## Wireless Positioning Unit “EPU-200” Series Model Change Notice

A model change for the Wireless Positioning Unit “EPU-200” series will occur as follows.

The backwards compatible model will be the "EPU-220" series (scheduled for release on June 29, 2021).

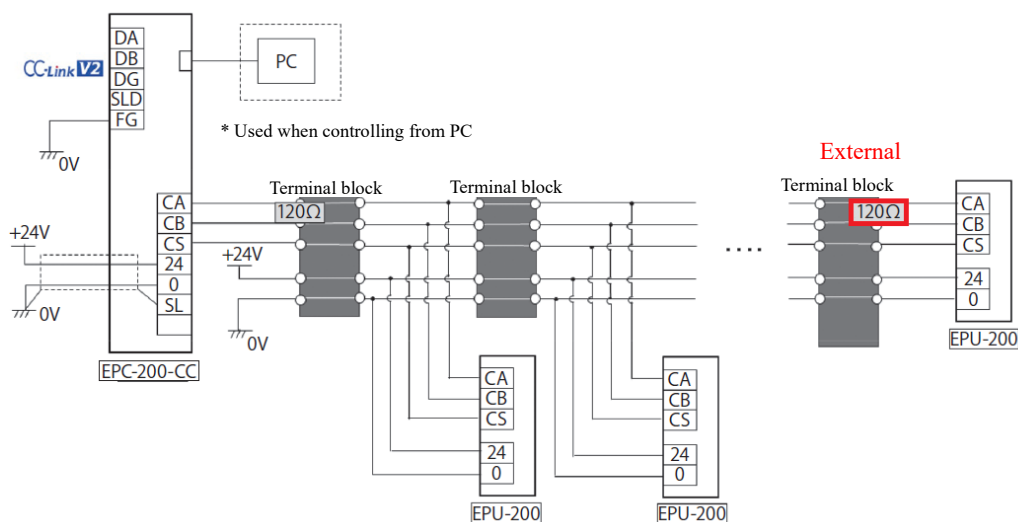
\* The housing will not change. Discontinued products and their successors can be distinguished by the part number listed on the nameplate on the side of the unit.

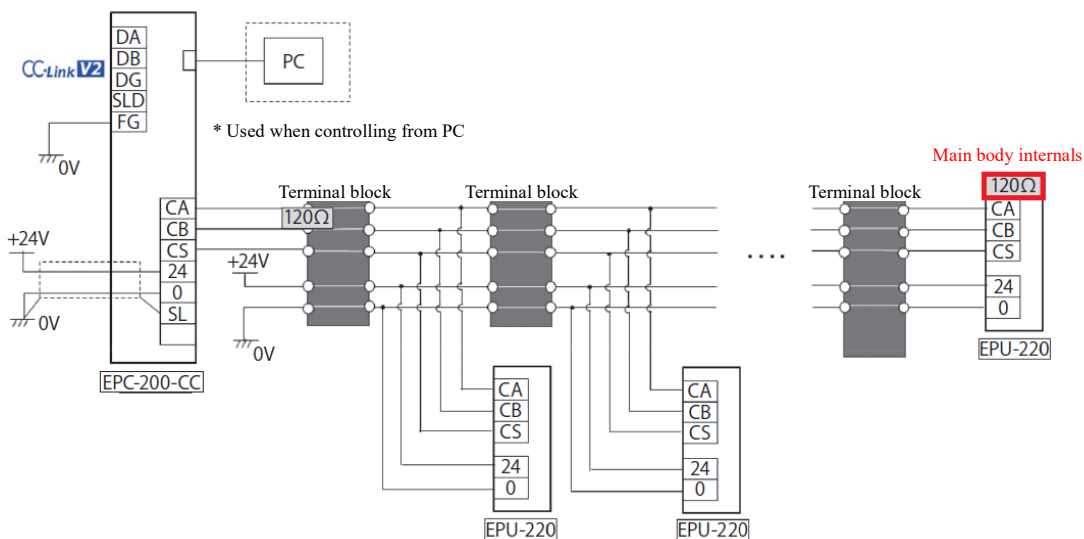
The RS-485 communication line terminating resistor ( $120\Omega$ ) is now built into the unit instead of being external, and the settings can be changed as desired.

- Existing wiring when using “EPU-200”

- Wiring when using “EPU-220”
